Addendum to Environmental Impact Report

Addendum Date: May 19, 2017

Project Title: Geary Corridor Bus Rapid Transit Project

Proposed Modification: Outer Richmond Transition Area

Figure 2. Hybrid Alternative Bus Lane Configuration Change between 26th and 28th Avenues Proposed in the Final EIS

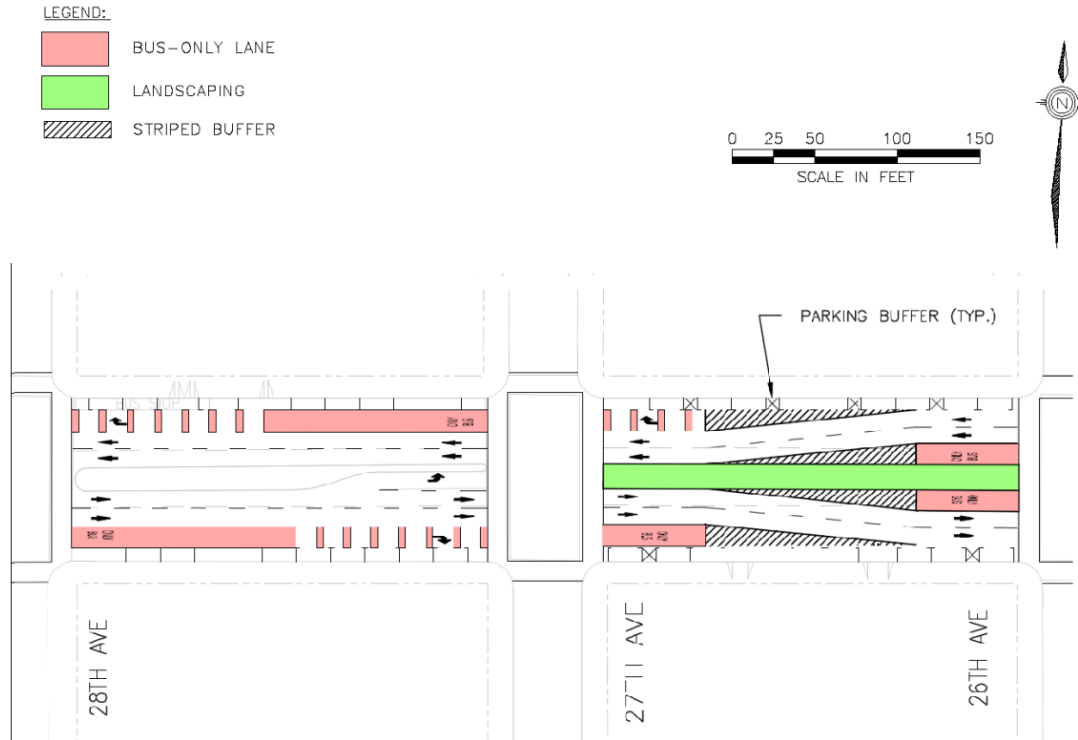
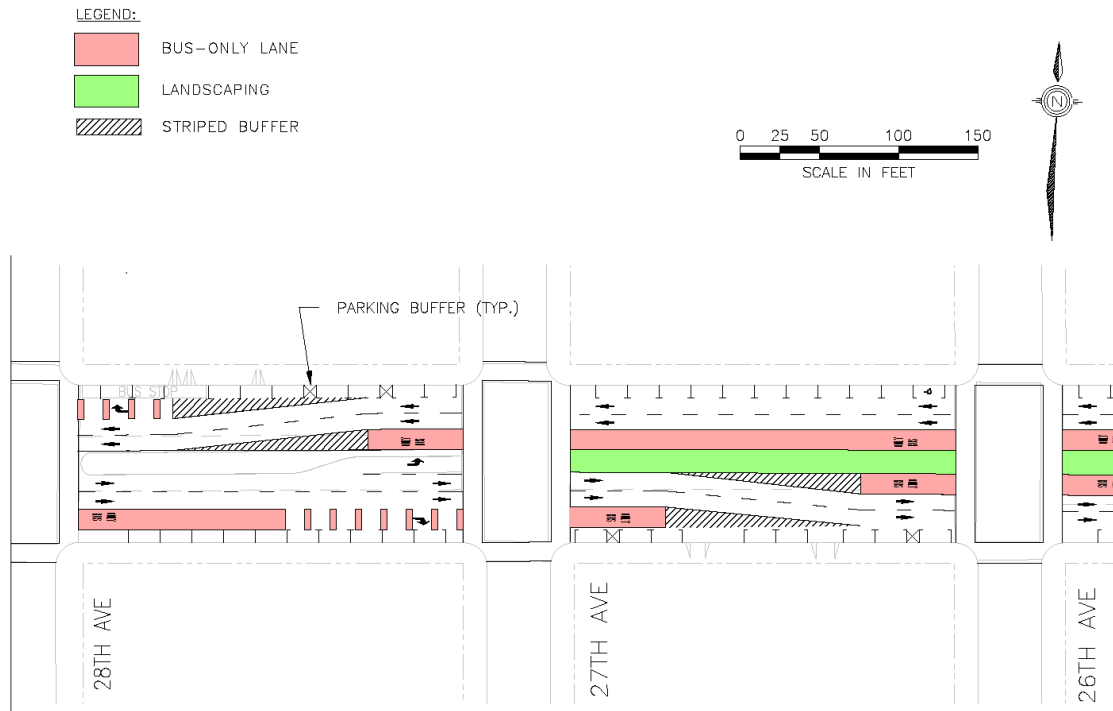
The northern side of the block between 26th and 27th Avenues is occupied by the Holy Virgin Cathedral (6210 Geary Boulevard), a religious and community facility. To better accommodate the parking and loading concerns of the facility, the agencies have proposed to modify the transition, as shown below in Figure 2.

As shown in Figure 2, the *westbound* transition would shift one block to the west, to the block between 27th and 28th Avenues. In other words, the center running bus lane would continue for one additional block west. Buses would therefore transition from center running to side running lanes between 27th and 28th Avenues.

No parking buffer areas would be installed on the north side of Geary (immediately adjacent to the Cathedral) between 26th and 27th Avenues, thus preserving two additional parking spaces (retaining 11 of the existing 18 spaces). With this design, the number of parking spaces remaining on the north side of Geary between 27th and 28th Avenues would not change relative to the project as proposed in the Draft EIS/EIR and the Final EIR: a total of eight parallel spaces, an increase of one space over existing conditions.

The *eastbound* transition would remain as proposed in the Draft EIS/EIR and Final EIR, between 26th and 27th Avenues on the south side of Geary Boulevard. No modification to the eastbound transition is proposed.

- Additional red roadway coloring (denoting a bus-only lane) in the westbound innermost (closest to center) lane for approximately one third of Geary between 27th and 28th Avenues.
- Striping of parking buffers on the north side of Geary between 27th and 28th Avenues, instead of between 26th and 27th Avenues as previously proposed, resulting in the provision of two additional parking spaces between 26th and 27th Avenues.

Prior to the proposed modification, the westbound transit signal queue jump was to have been located at 26th Avenue; eastbound, the queue jump was to have been at 27th Avenue. With the proposed modification, both transit signal queue jumps would be located at 27th Avenue. Based on analysis conducted by SFMTA, this change in queue jumps would not require any change to pedestrian signal timing at either 26th or 27th Avenues. Indeed, the consolidation of both queue jumps to one intersection would allow for more efficient signal coordination.

Figure 3: Proposed Construction Phasing

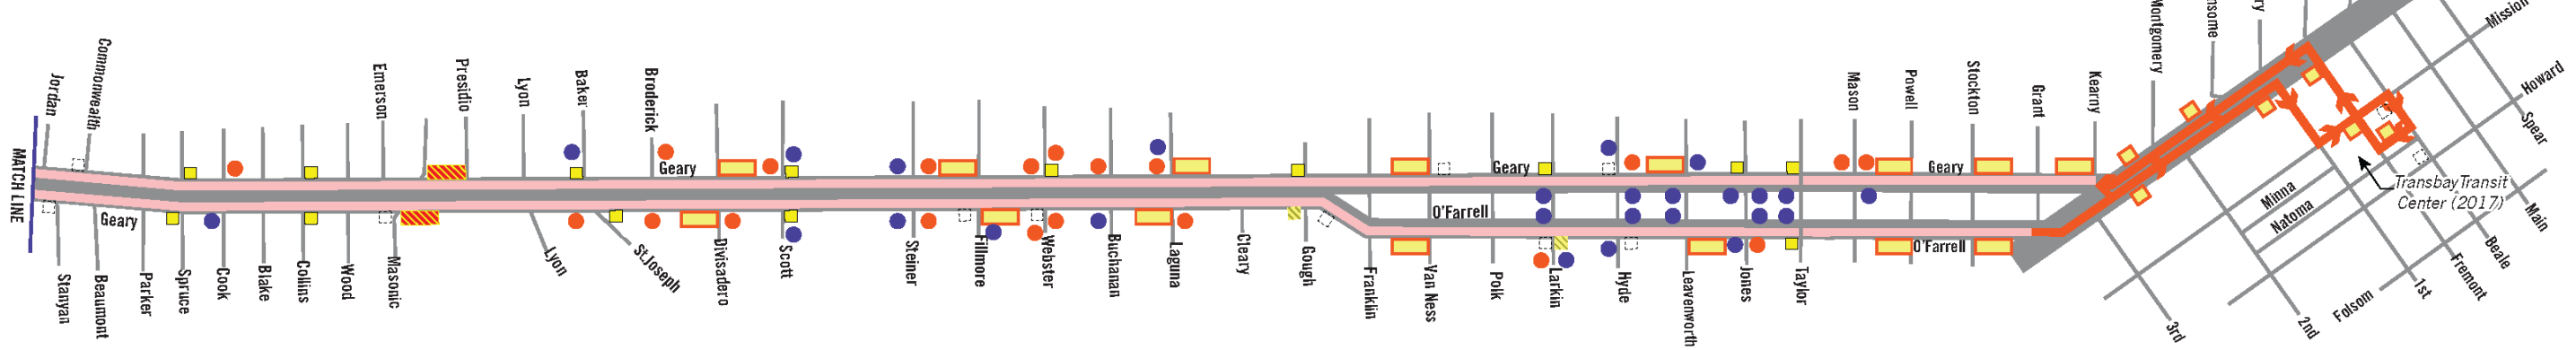
As illustrated in Figure 3 below, Phase I would entail work east of Stanyan Street where BRT would operate in side-running bus-only lanes. Phase II would include work west of Stanyan Street, where BRT operations would be in predominantly center-running bus-only lanes.¹ The project would still be constructed using the Staggered Multiple Block Segment Approach described in Section 4.15 of the Draft EIS/EIR.

Phase I and Phase II would *each* be expected to take approximately 100 weeks, including both active and inactive periods and anticipated separate utility work. With more information now available with regard to specific phasing activities and SFMTA's recent experience with similar projects, the duration of construction activities on any given block could take up to 12 months for areas with a larger scope of work inclusive of active and inactive periods, depending on construction scheduling, construction operations, and the extent of the utility work involved. The majority of blocks would have a shorter anticipated construction duration.
